FIG. 11

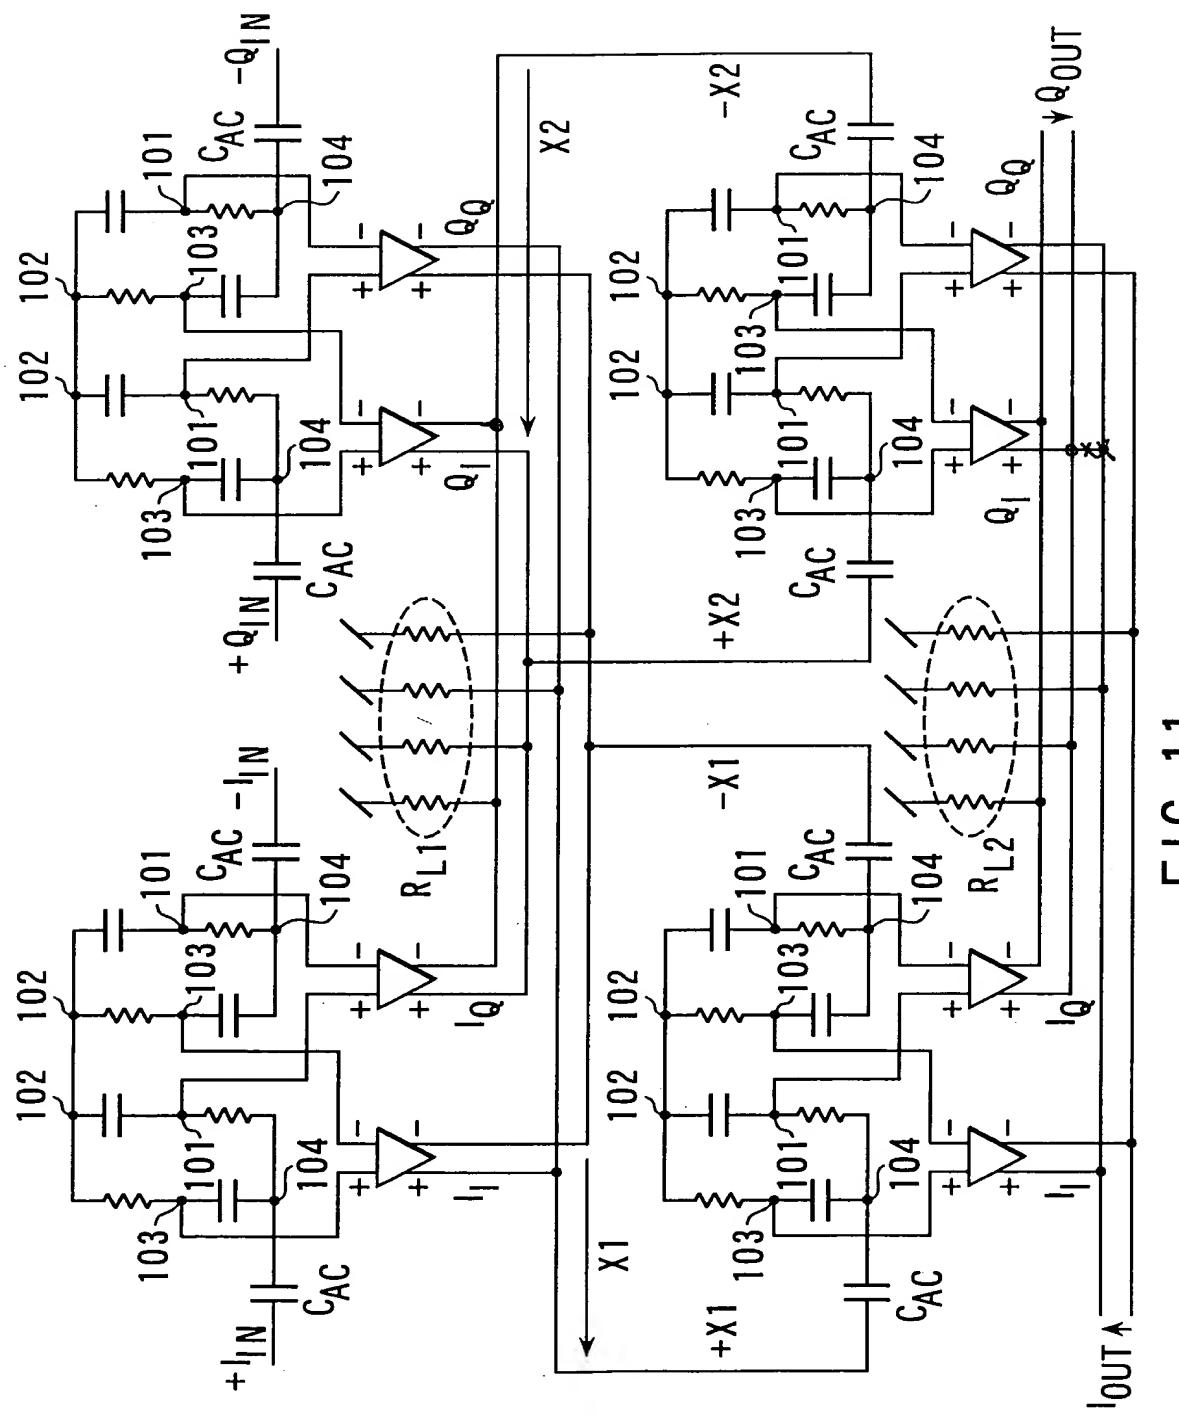
originally filed at page 38, lines 2-6. Figure 11 is further amended to show an obvious connection between R_{L1} and - Q₁. These changes, therefore, are not believed to raise a question of new matter.¹
